**ATCO Electric Yukon (AEY)  
2023-2024 General Rate Application (GRA)**

**Information Responses Round 1 to:  
John Maissan (JM)  
Received: September 6, 2023**

**Reference:** Business Cases  
Business case No. 12

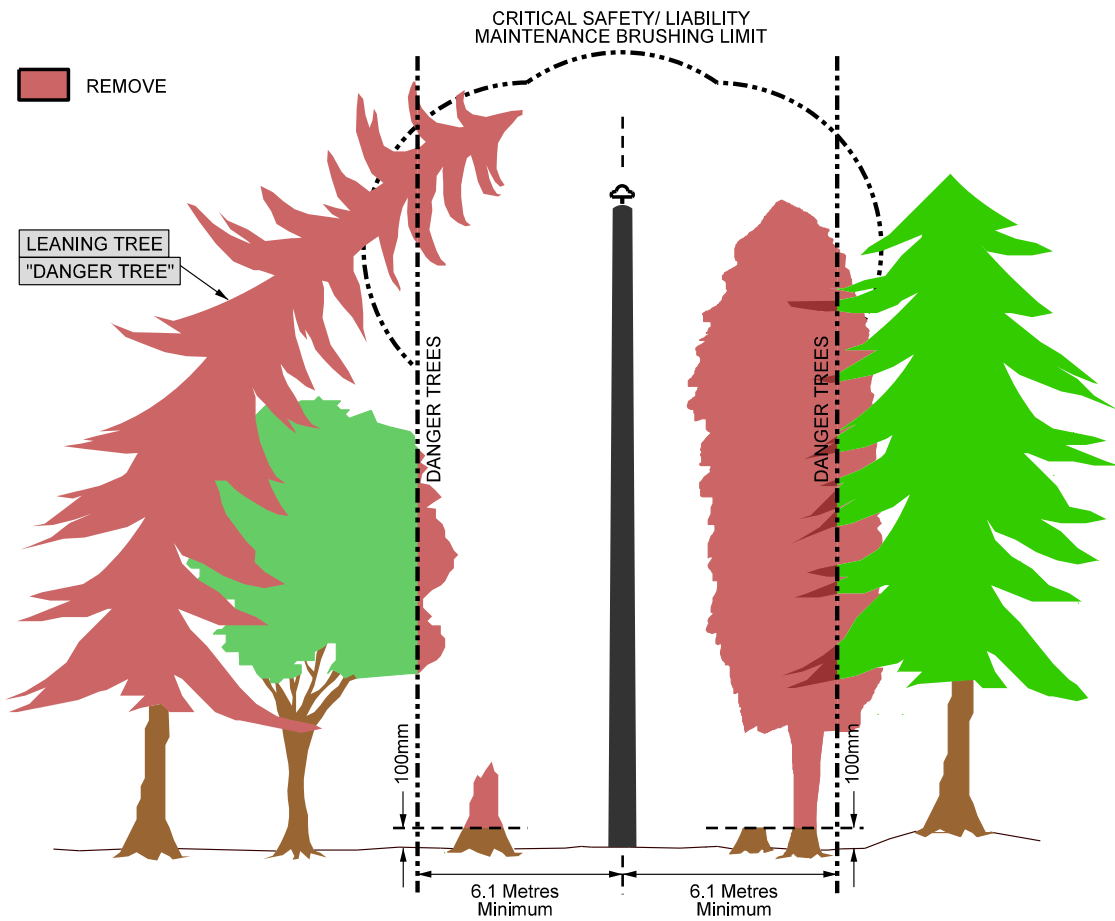
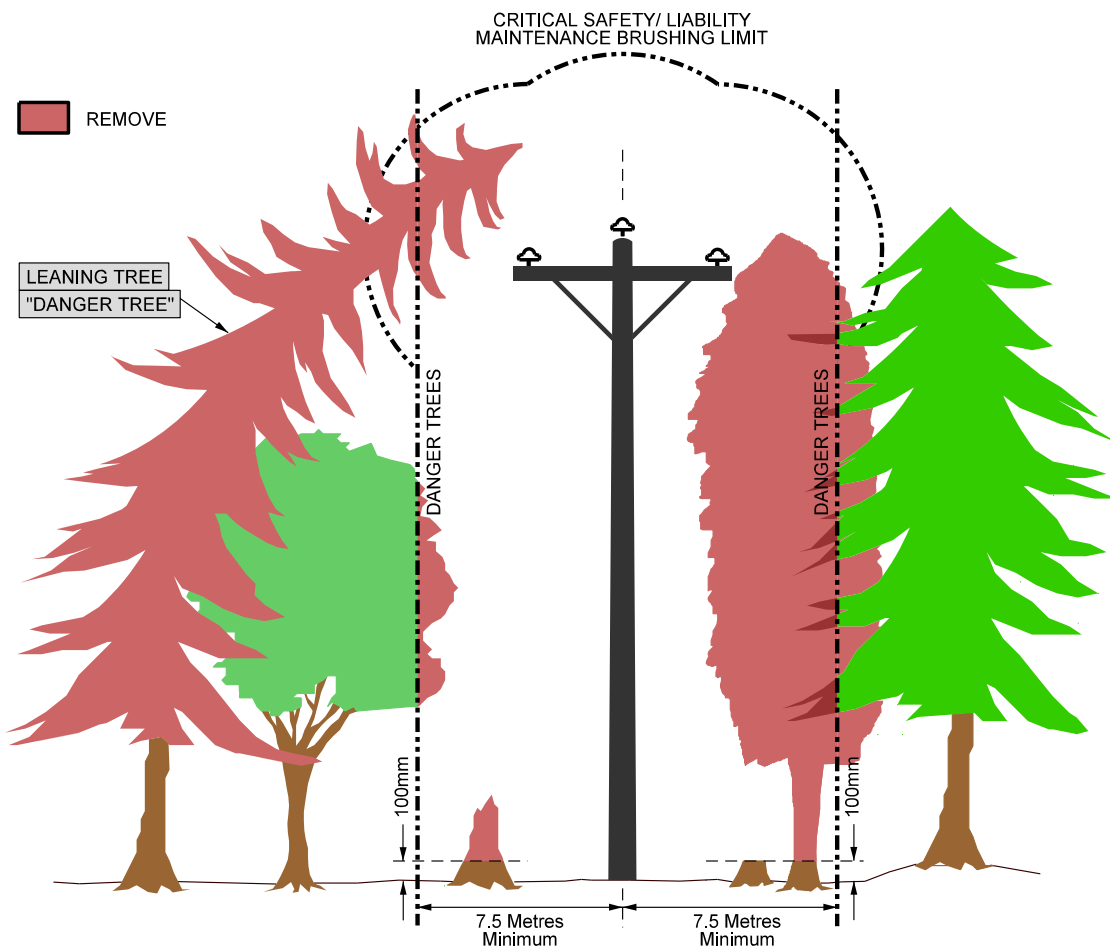
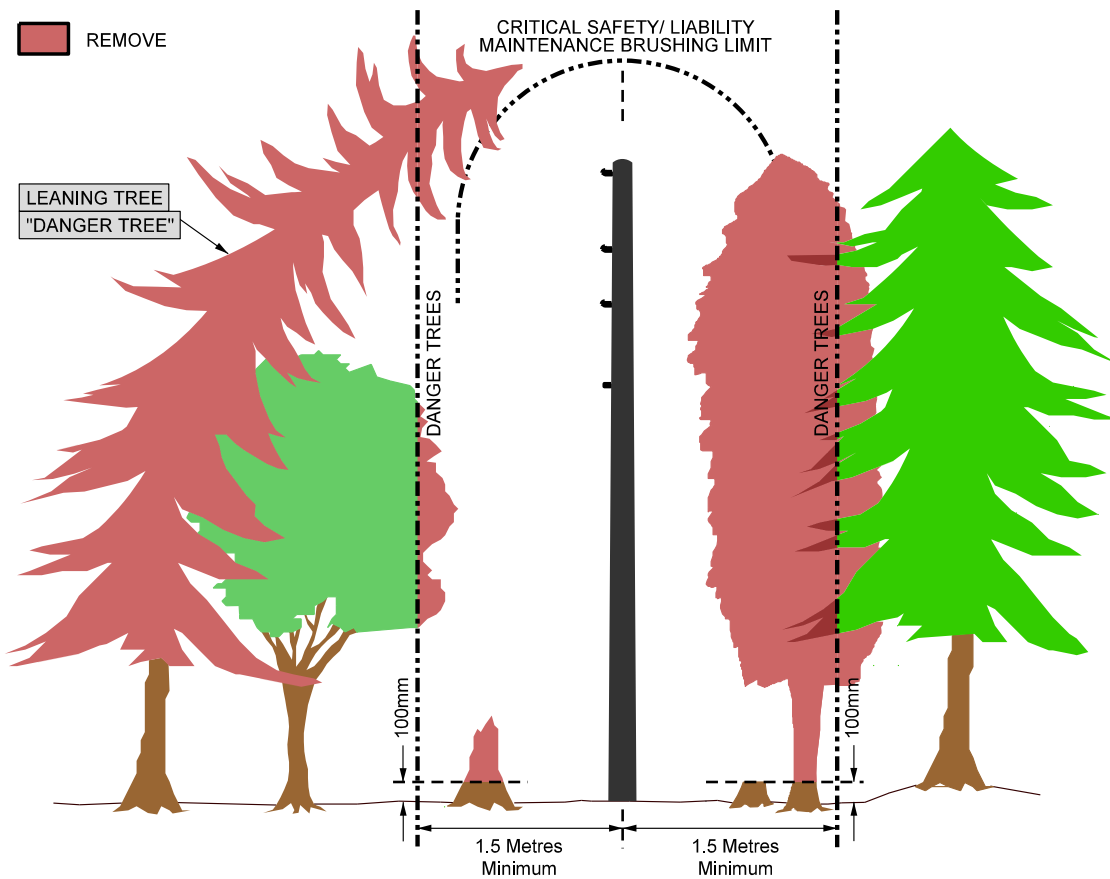
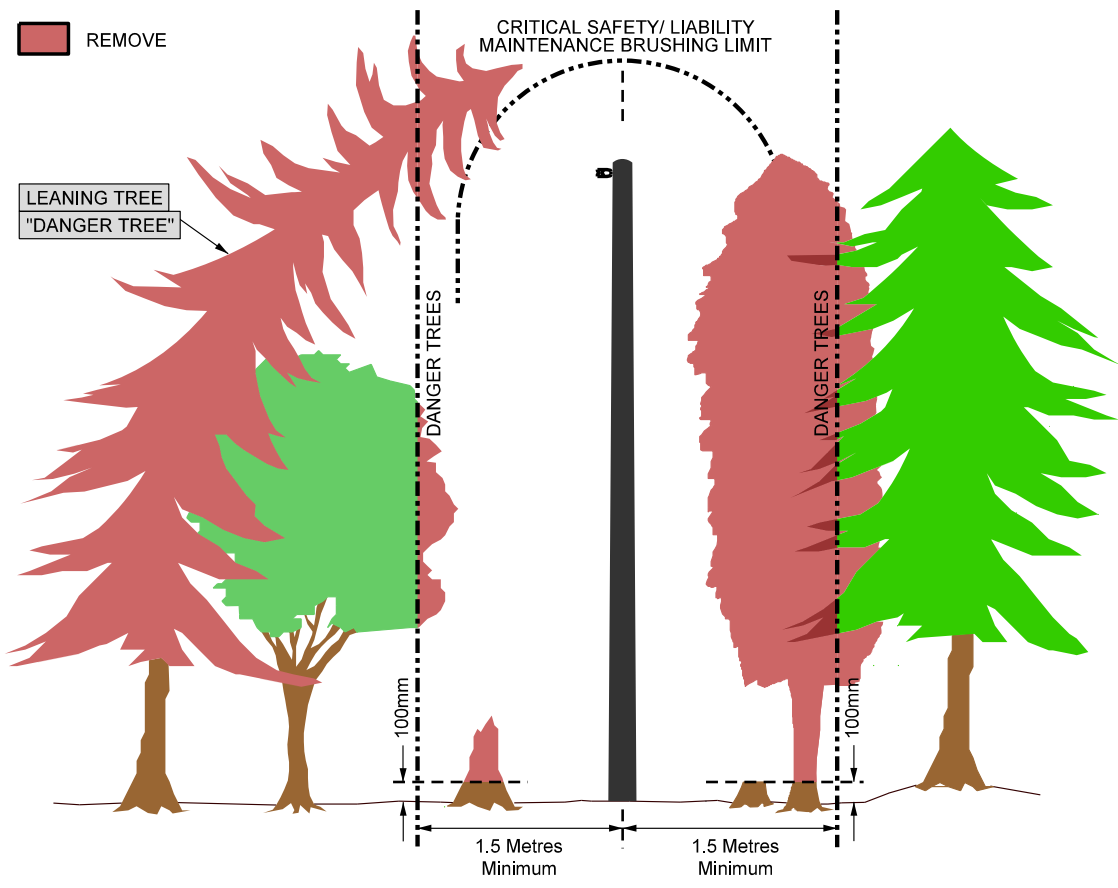
**Requests:**

ATCO Electric Yukon will arrange for the Powerline Crew to cut down at time of construction or send out a Qualified Utility Brusher to cut down.

VOLTAGE	RIGHT-OF-WAY WIDTH	TREE TO CONDUCTOR CLEARANCE
2400 V	-	3m
4160 V	-	3m
7200 V	12.2m ( 6.1m EACH SIDE )	5m
14000 V	12.2m ( 6.1m EACH SIDE )	5m
24940Y/14000 V	15.0m ( 7.5m EACH SIDE )	5m

**Reference:** Business Case No. 31

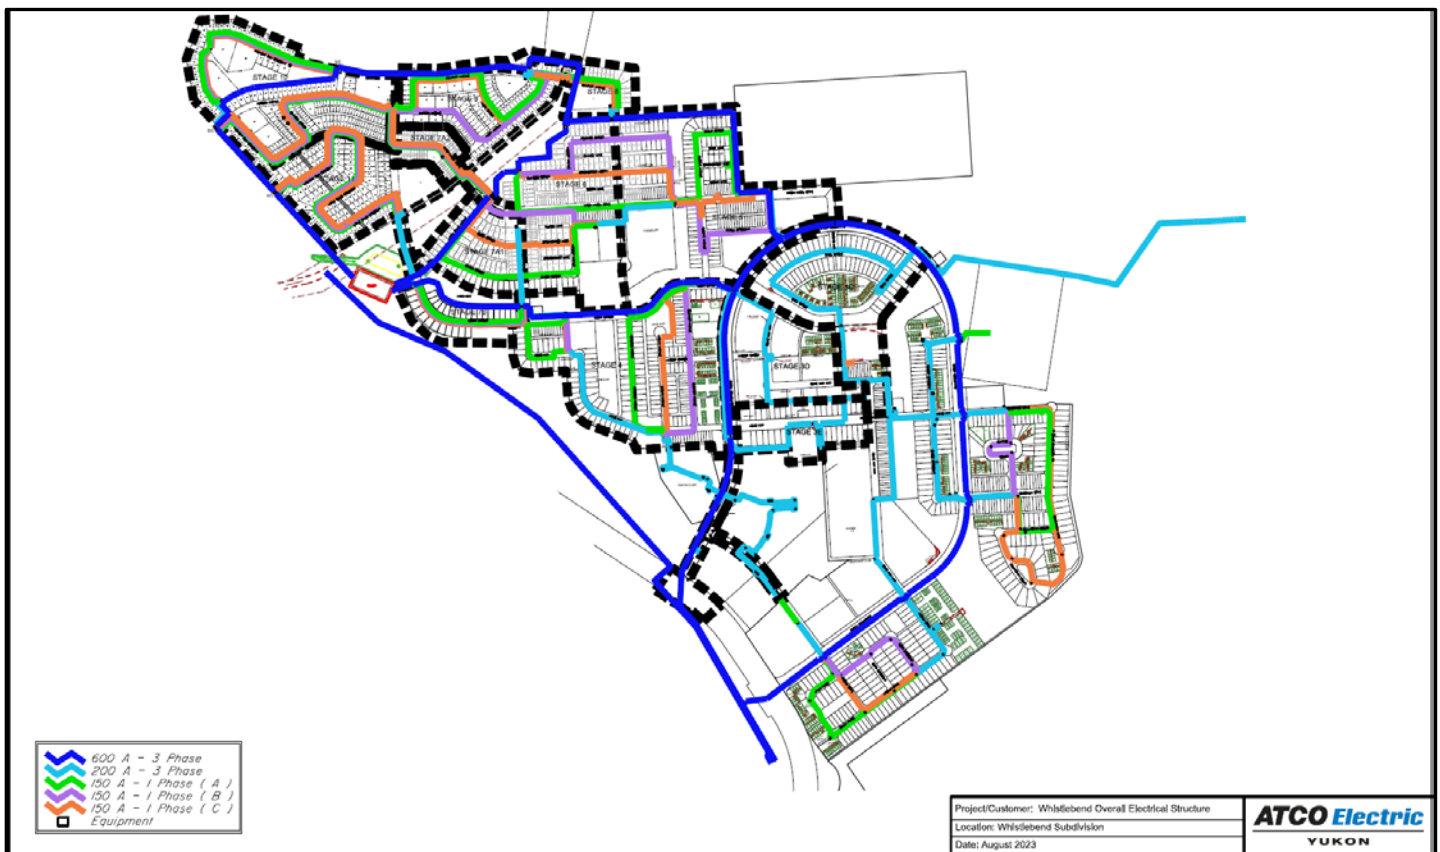
- (a) Please provide a readable (higher resolution) copy of Appendix A.
